MITIGATION PLAN

**Morgan Branch Restoration Site
Buncombe County, North Carolina
RFP# 16-007724 (Issued: 3/1/19)
DMS Project Number 100127
DMS Contract 7909
USACE Action ID: SAW-2018-01163
DWR #: 20181030**

Re: NCIRT Review and USACE Approval of the NCDMS Morgan Branch Mitigation Site /
Buncombe County

USACE ID: SAW-2018-01163
NCDMS Project # 100127
NCDWR # 2018-1030 v1

FIGURE 10. PROPOSED MONITORING PLAN TYPE AND EXTENT MORGAN BRANCH RESTORATION SITE BUNCOMBE COUNTY, NC

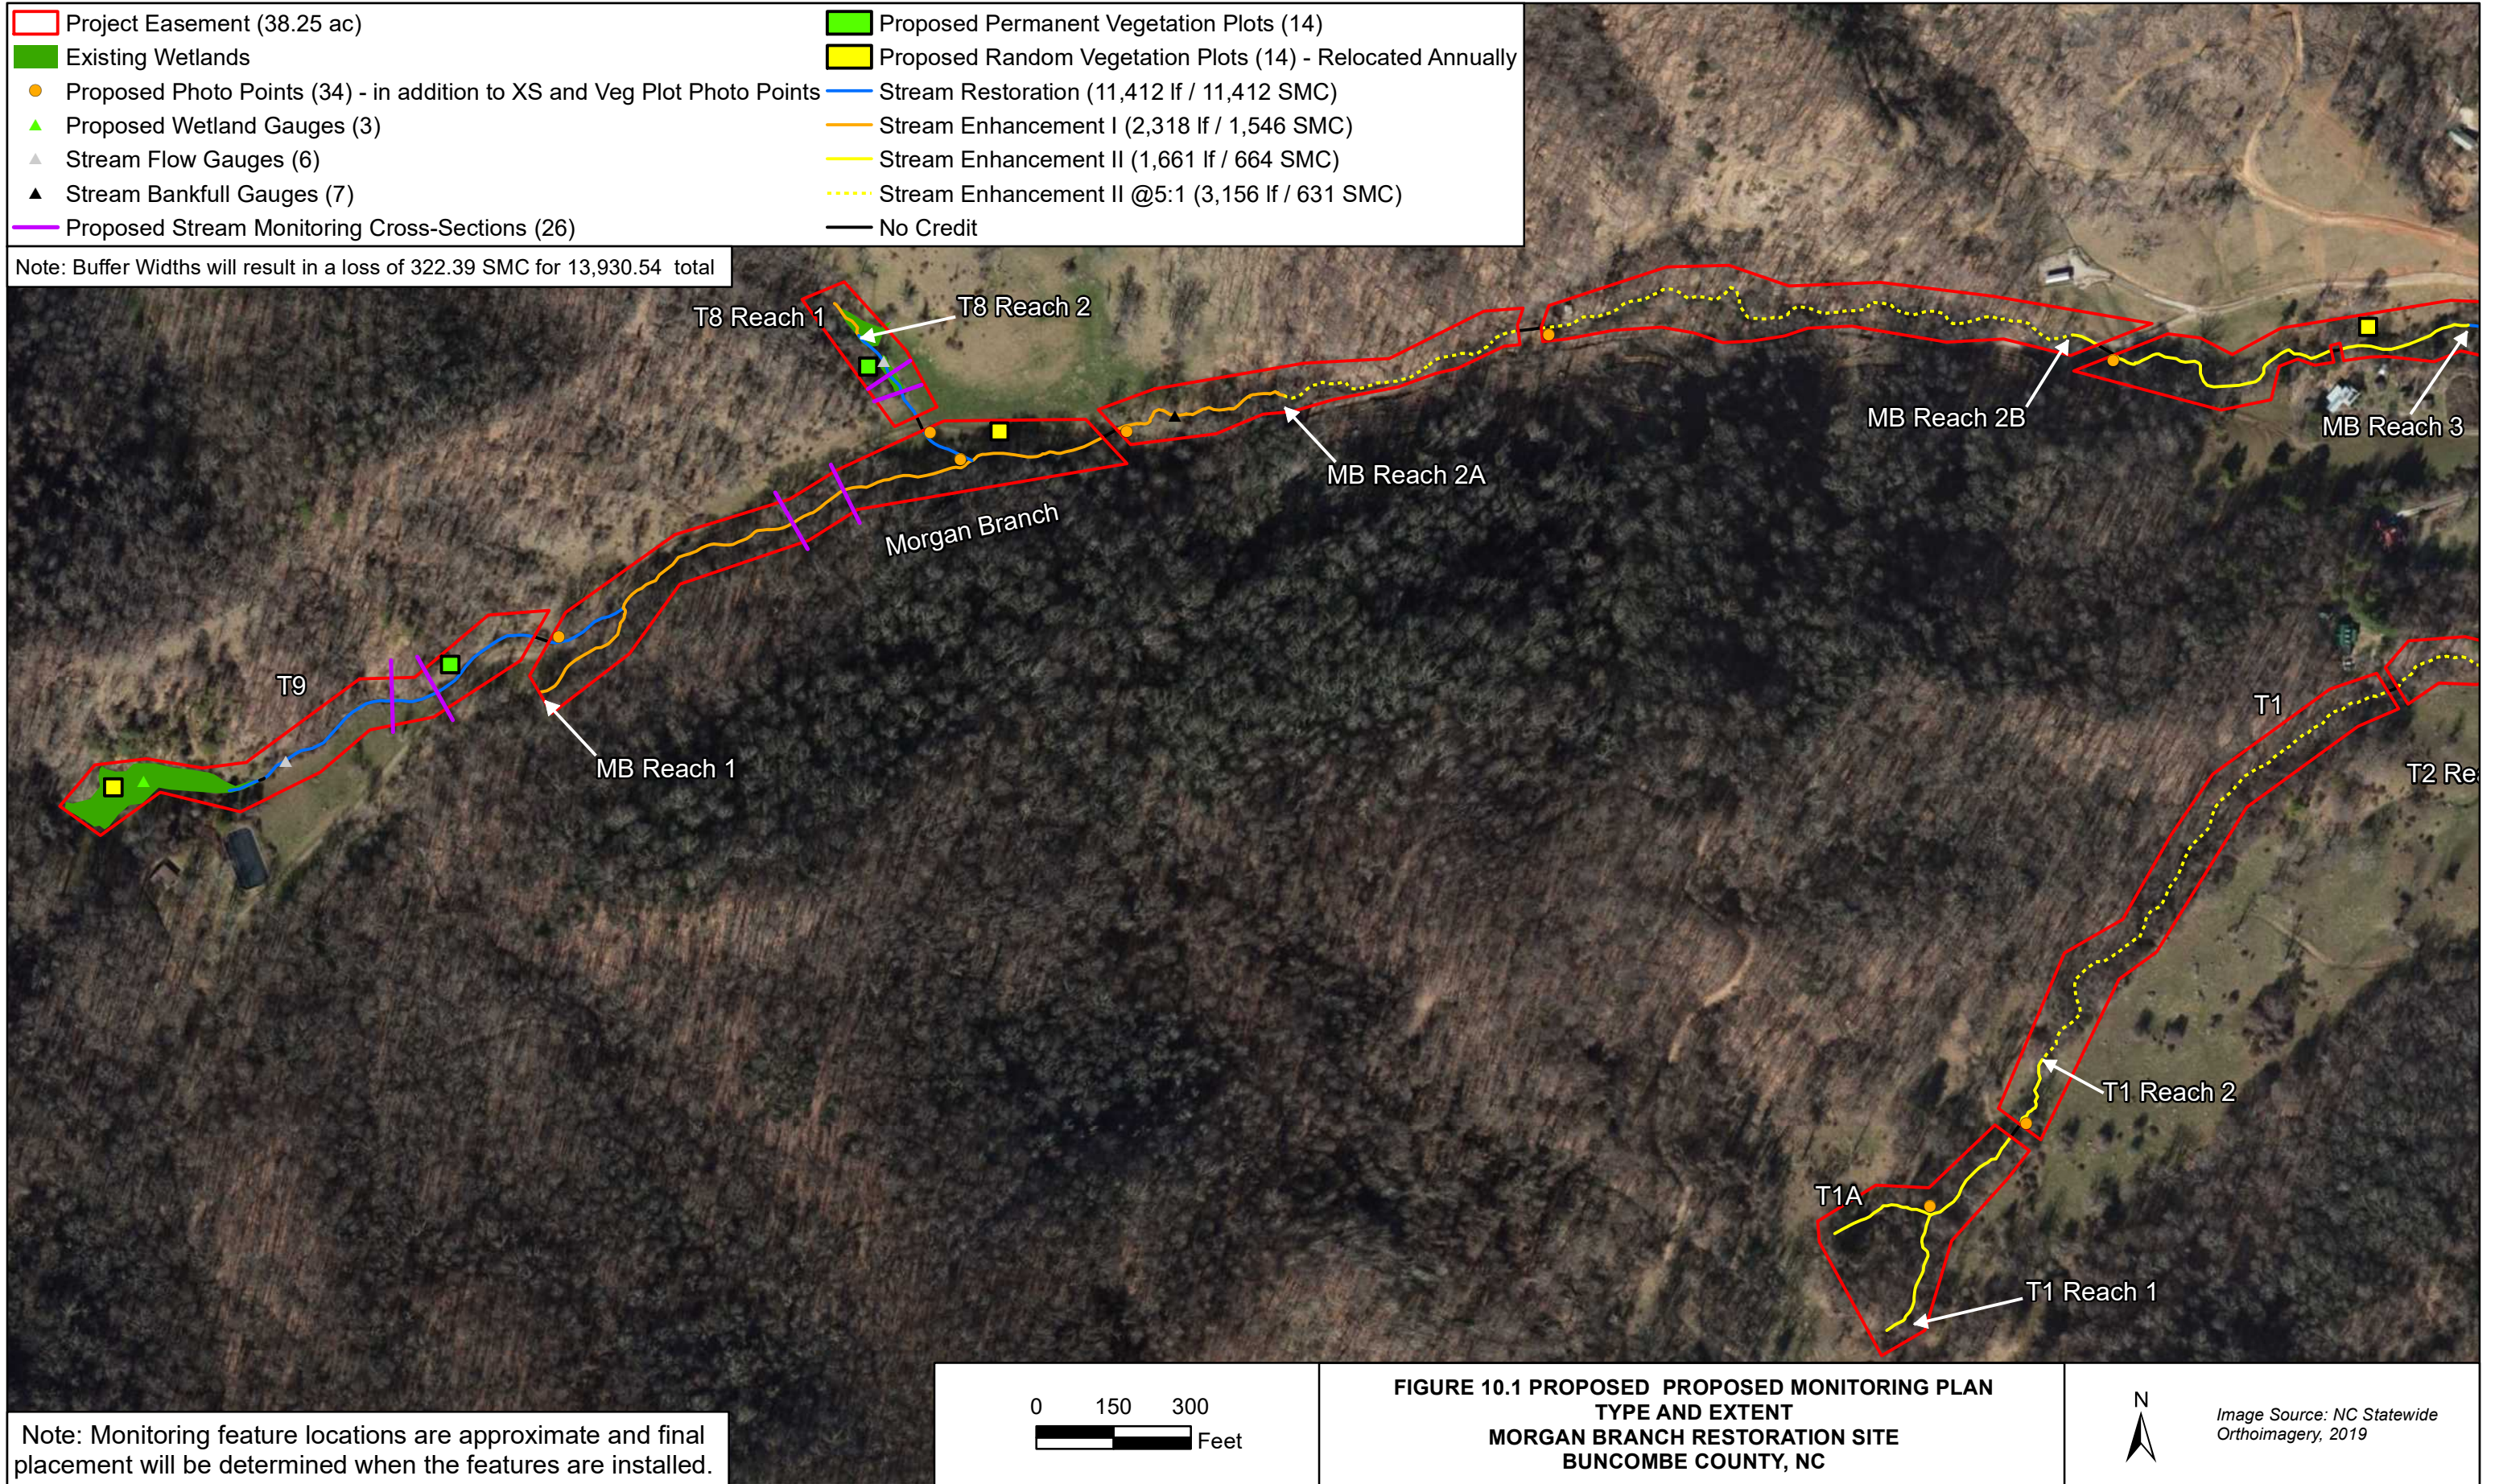
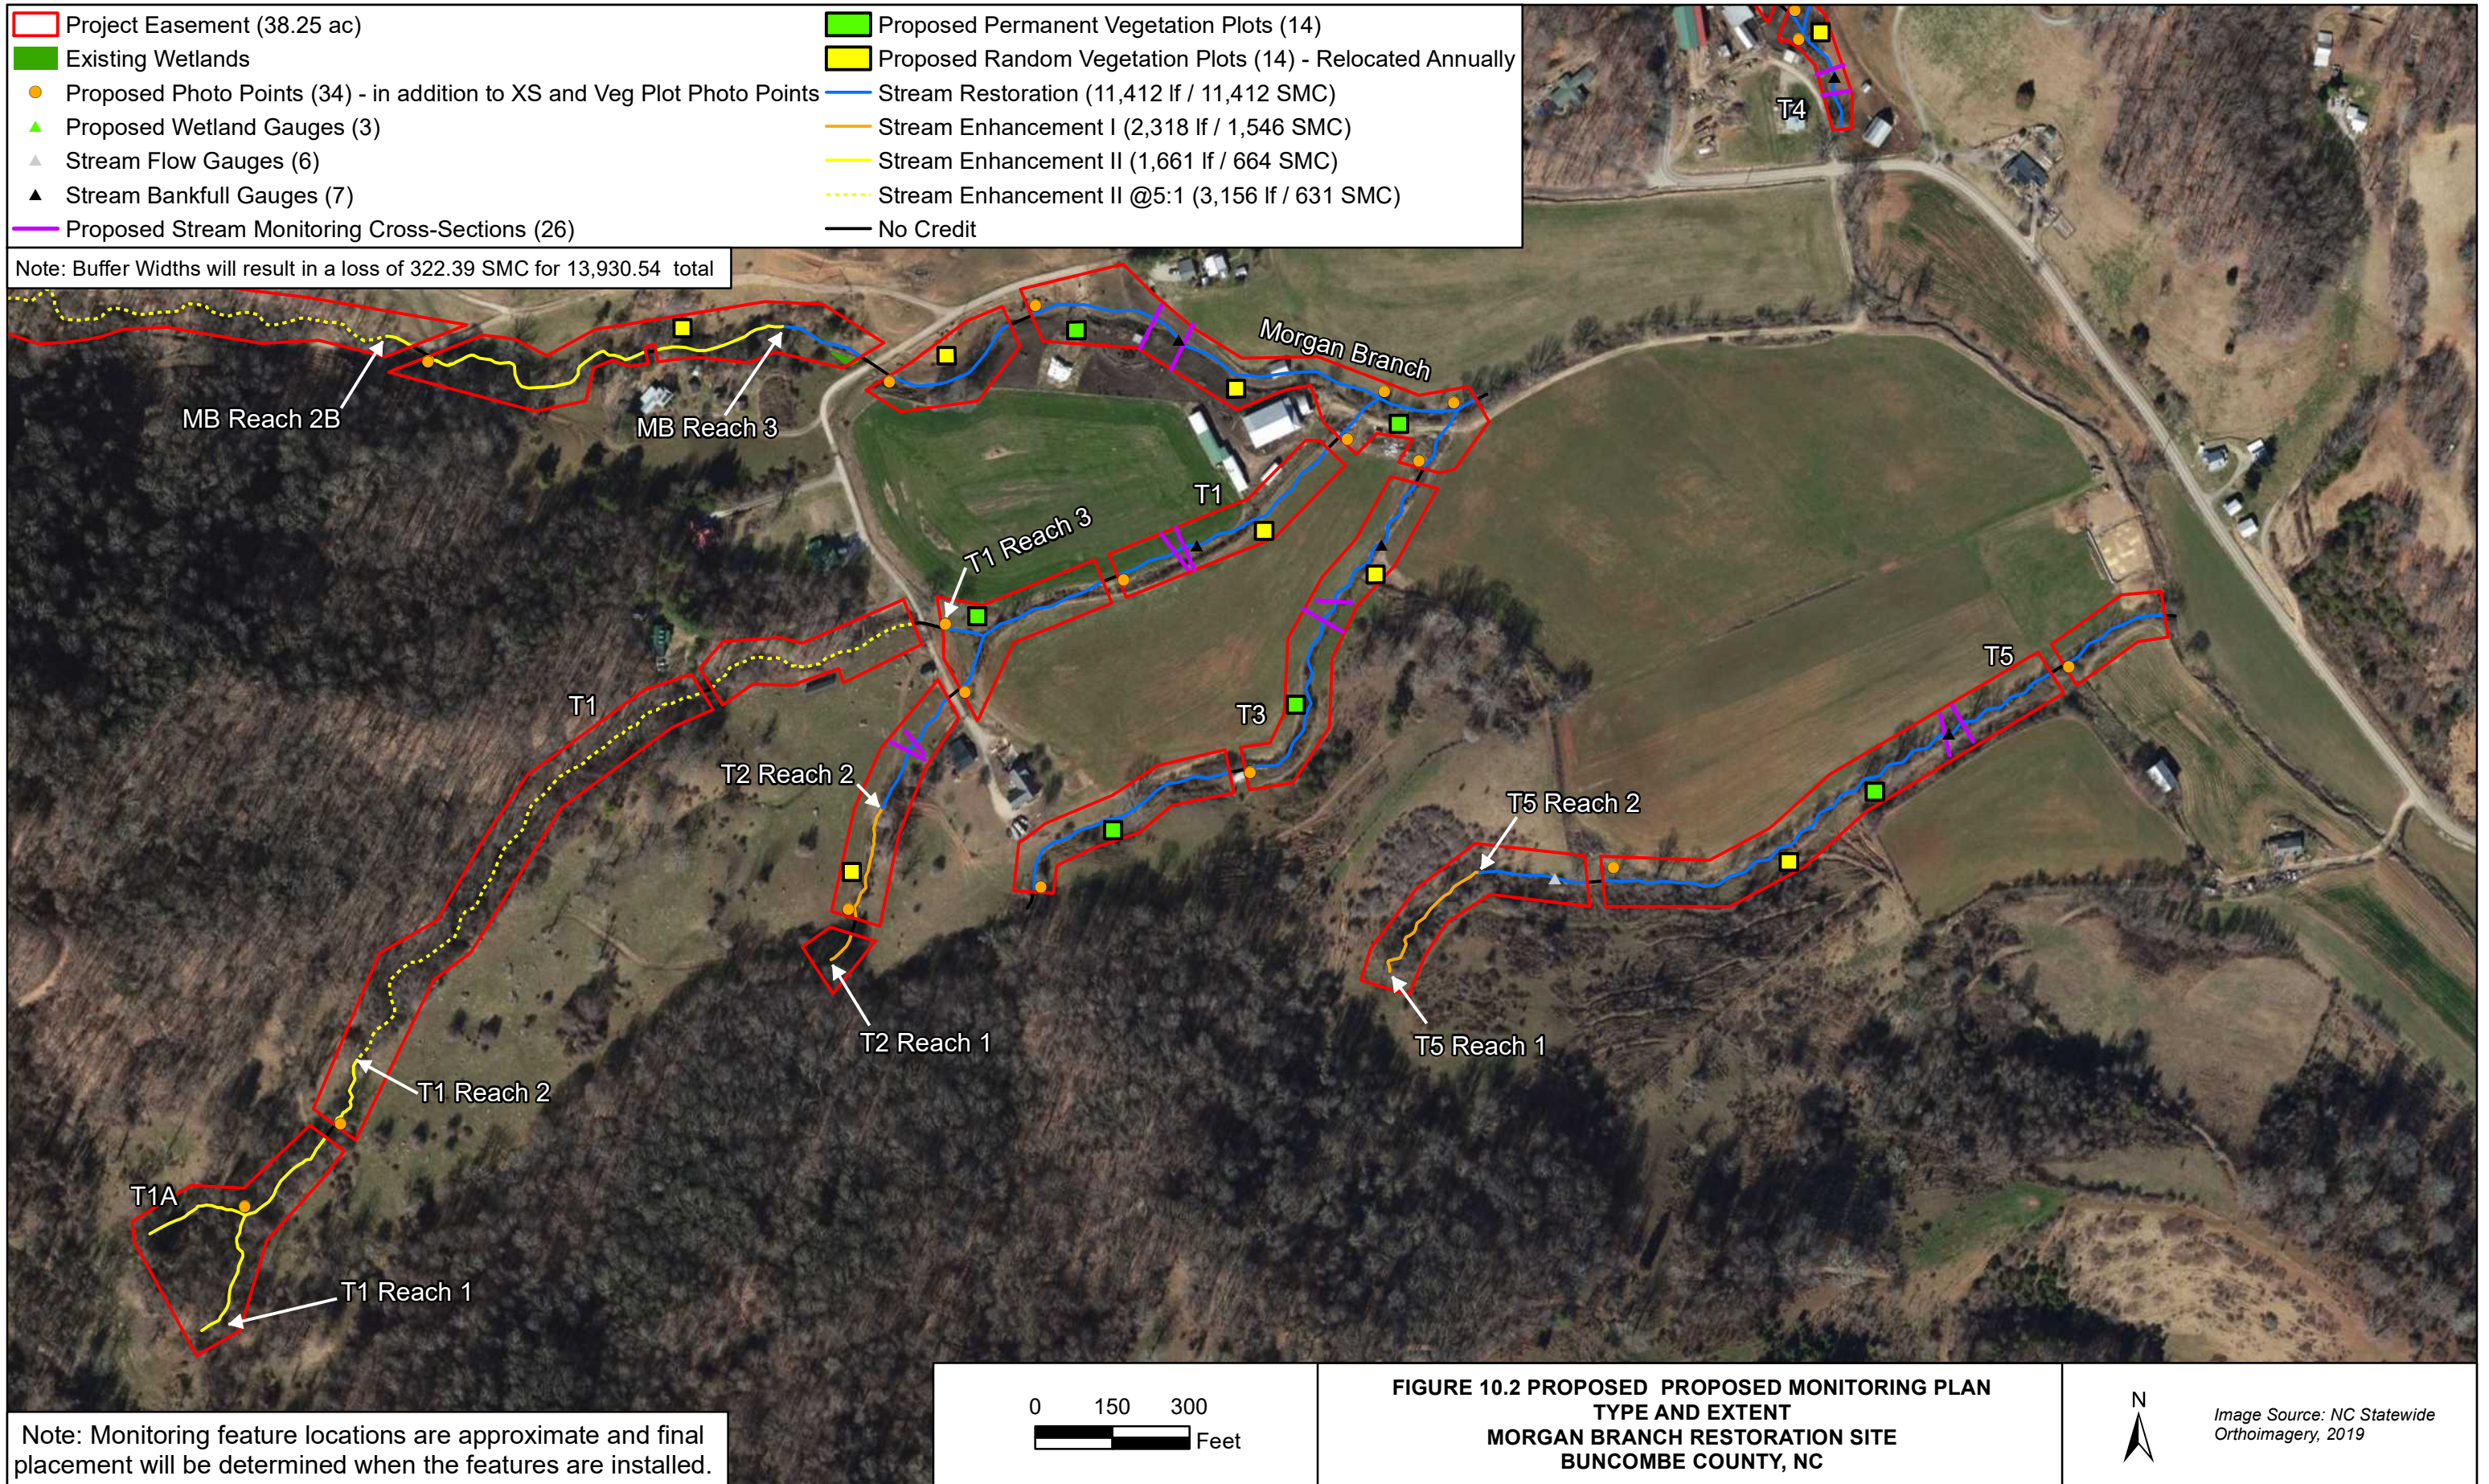
13. Please add the existing project wetlands to Figures 9 and 10. These figures (especially Figure 10) should be split into multiple sheets at a more viewable scale.

The gauge has been relocated and is shown on Figure 10.2.

We will add an additional gauge to the wetland at the top of T7. Wetland gauges are discussed in Section 6.8 and shown on Figure 10.
